A-5-NPB-18-0006 (NICHOLSON CONSTRUCTION)

EXHIBITS

APPEAL FROM COASTAL PERMIT DECISION OF LOCAL GOVERNMENT

A RESOLUTION OF THE PLANNING COMMISSION OF THE CITY OF NEWPORT BEACH, CALIFORNIA, APPROVING VARIANCE NO. VA2016-005 AND COASTAL DEVELOPMENT PERMIT NO. CD2017-080 TO ALLOW THE CONSTRUCTION OF A NEW SINGLE-FAMILY RESIDENCE, FOR PROPERTY LOCATED AT 2607 OCEAN BOULEVARD (PA2016-170)

Project Height comparison to Code Allowed Height

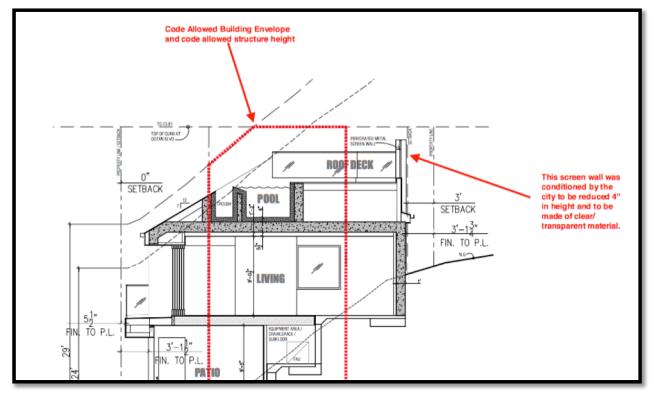
In his letter, Mr. Mosher indicates the project is not "designed or sited" to minimize impacts to public coastal views (CLUP Policy 4.4.1-2). Although Mr. Mosher makes this erroneous assertion, the project is actually designed specifically with consideration to coastal views. This property is located on the bluff side of Ocean Boulevard and therefore restricted to a maximum height of 24 ft. and 29 ft. for flat and sloped roofs respectively, and not allowed to exceed the curb height of Ocean Boulevard (Local Coastal Program Implementation Plan Section 21.18.030, Table 21.18-2 and 21.30.060 B4).

The proposed development complies with the above-referenced height limitations identified in the LCP Implementation Plan. **IN FACT**, the project structure height is almost two feet below (22 inches) the curb height of Ocean Boulevard. The project is lower in height than what would otherwise be allowed by the LCP (see comparison below).

In addition to being designed at a height less than required by the LCP Implementation Plan, the project also complies with the side yard setbacks identified in the Implementation Plan. The two design components of any structure that would have a potential impact on public views would be structure height and structure width – both of which relate to the horizontal and vertical view paths. Both of these design components of the project comply with the LCP Implementation Plan. The LCP Implementation Plan has been reviewed by Coastal Commission to ensure the regulations within the Implementation Plan provide for development that uphold the intent of the LCP and uphold the policies, goals and objectives of the LCP. Moreover, the Coastal Commission has certified the City's LCP as consistent with the Coastal Act. Since the design of the project complies with the regulations within the LCP Implementation Plan related to height and side yard setbacks, the project is consistent with CLUP Policy 4.4.1-2.

Home Cross Section

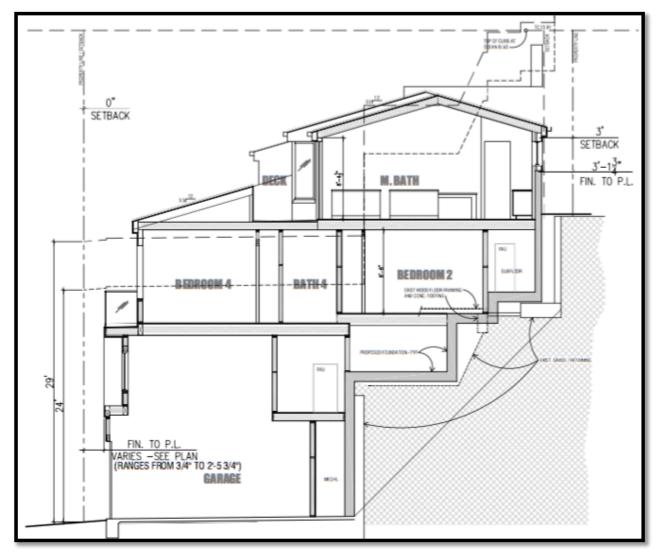
Mr. Mosher mistakenly asserts that the site is not designed to minimize impacts to natural landforms (CLUP Policy 4.4.1-3). The property owner and homebuilder specifically designed the new home with consideration for the natural slope on this property. The new home is designed to use the existing retaining wall structures that hold the existing home in place so as not to unnecessarily disturb the existing slope. Additionally, the home does not include the construction of a basement, as that would necessitate a complete reconstruction of the slope. Instead, the project "treads lightly" on the property and within the neighborhood by being designed into the slope and nesting with the existing landform of the hillside. Please note that in the building cross-section below, the building uses existing structures and conforms to the existing slope and minimizes impact to existing natural landforms in a consistent with CLUP Policy 4.4.1-3.

Design of Updated Pedestrian Access

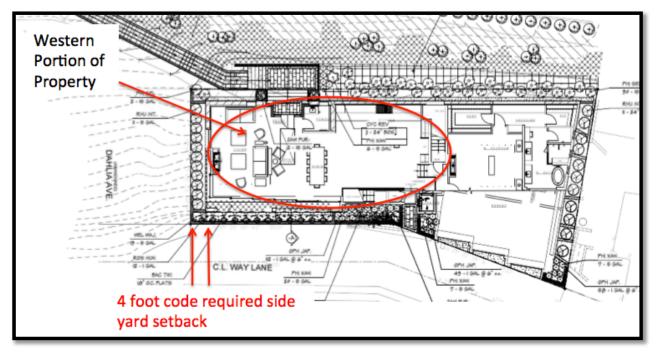
Mr. Mosher further asserts that the development would "privatize" a significant amount of public view land above and to the west of the property. This assertion is completely untrue. The property currently takes pedestrian access from Ocean Boulevard, which it has done for more than 40+ years. Mr. Mosher implies that this walkway is a new element introduced into the area, when, in fact, the access predates the Coastal Act of 1976. The design of the walkway is being coordinated between the property owner and the City to ensure that any future sidewalk or other use of the area would not be affected by pedestrian access to the property. The original design of the pedestrian access (as indicated below) was configured this way due to the hazard of having a pedestrian entry immediately entering the China Cove Ramp, where there is no connection to any safe pedestrian path.
